# SERVICE BULLETIN

TR-9000

SUBJECT: TR-9000 CW, SSB TX INSTABILITY

DATE 5/29/80

#824

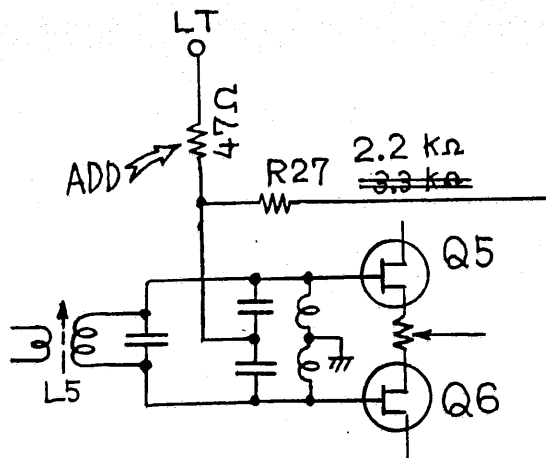
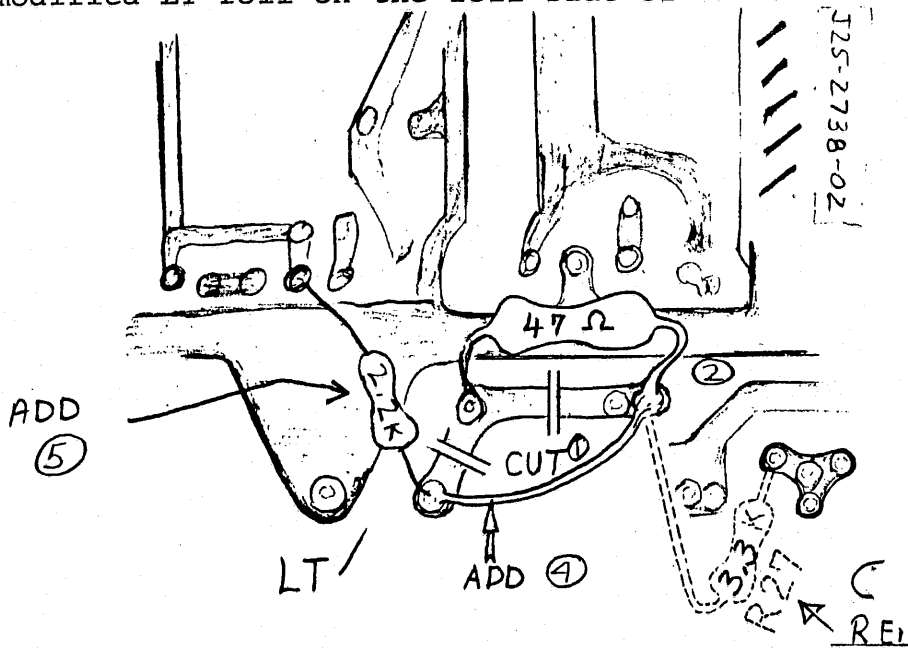
Complaints of FMing in SSB, or CW chirp may be eliminated by minor changes to the TX mixer circuit.

On the TX unit X56-1370-10, perform the following changes:

1. Cut the LT foil path.
2. Install a  $47\Omega$  resistor on the foil side of the PCB.
3. Remove R27,  $3.3K\Omega$  and delete.
4. Jumper the cut foil.
5. Install a  $2.2K\Omega$  resistor from Q12 collector to the modified LT foil on the foil side of the PCB.

#825

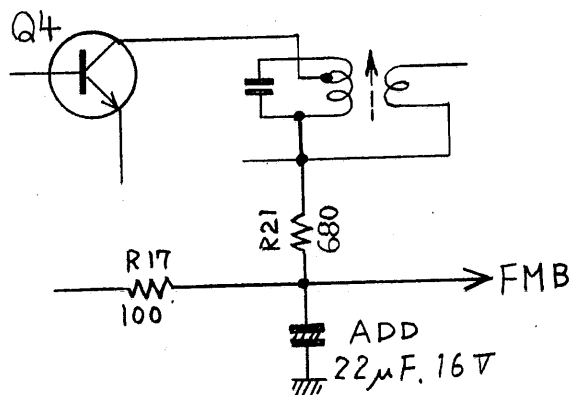
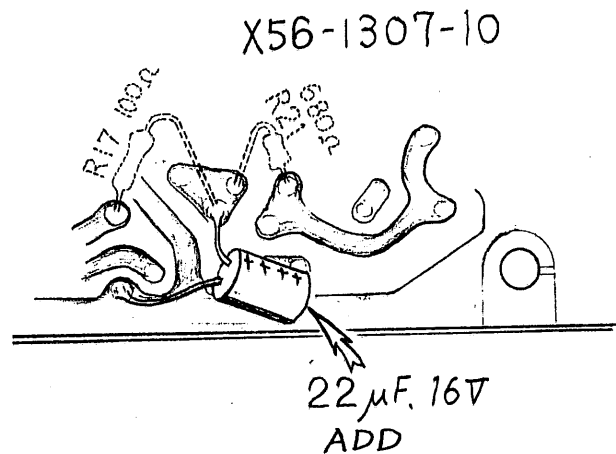
Pulse noise heard during SSB transmission may be reduced or eliminated by adding one capacitor to the TX unit.

On the TX unit X56-1307-10 add a 22 $\mu$ F 16V radial lead cap to the FMB line, as illustrated, on the foil side of the PCB. No adjustments are necessary.

#849

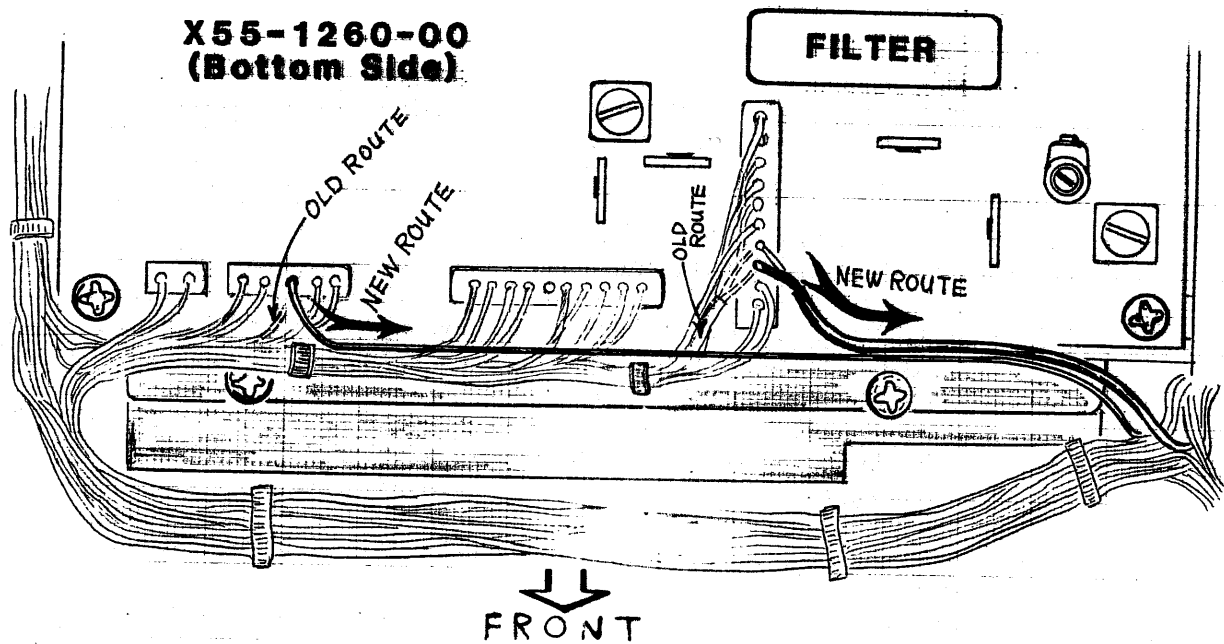
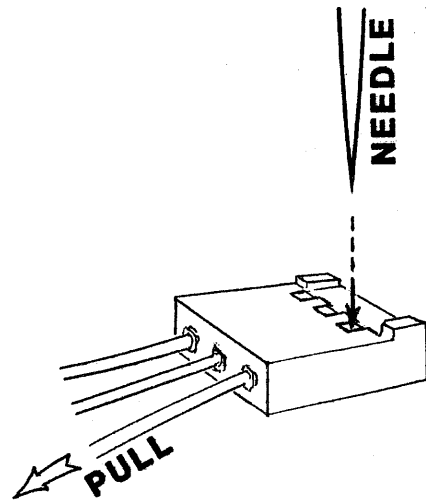
Distorted sideband transmission may have one of two causes. If normal alignment does not cure the problem, distortion or poor carrier suppression may be improved by rerouting two leads in the wire harness.

1. On early units, ascertain that R74, 47 $\Omega$  is present on the TX unit X56-1370-10 between connector 33, the LT line, and R27, 2.2K $\Omega$  (vicinity of Q5, Q6), and that R27 is 2.2K $\Omega$ . (Service Bulletin #824).
2. Verify TR-9000 Service Manual alignments, General section steps 4 (PLL), and 5 (HET frequency alignment).
3. TX section, steps #4 (power adjustment), 9 (SSB mic gain), 10 (carrier point) & 11 (carrier suppression).

1. Remove the bottom cover and unplug the speaker.
2. With the radio upside down and facing forward, locate connectors 8 and 10 at the front of the RX unit X55-1260-00. Connector # 8, pin 3 (violet) is the -6V DC line from the TX unit, connector # 31, pin 1. Connector # 10, pins 7 (signal) and 8 (ground) (green coaxial cable) is the MS pins 5 (sig) and 4 (gnd).

3. Carefully cut the cable ties (without cutting any leads) securing these two lines in the wire harness which runs to the left, around the upright Control unit, and then right behind the front panel as far as the Mode switch.

4. Carefully unplug each of these connectors by gripping the connector housing with a long-nosed plier.
5. Extract the terminal from the housing by depressing the locking tab and simultaneously withdrawing the lead with terminal. (see illustration on page 2).

6. Reroute these two lines from the behind the Mode switch, between the chassis and control unit, then left to their original connectors. Reinstall the terminals in their original positions in the connector housing.

7. Coil the excess of each lead and secure with cable ties. Retie the harness behind the front panel, along the left of the chassis, and back behind the control unit.

8. Readjust carrier suppression. Mod SW:USB, Mic terminal terminated with  $470\Omega$ . On the RX unit, alternately adjust TC1 & VR6 for minimum output at 145MHz. Carrier should be at least -40dB down.
9. Work is complete. Replace the bottom cover.
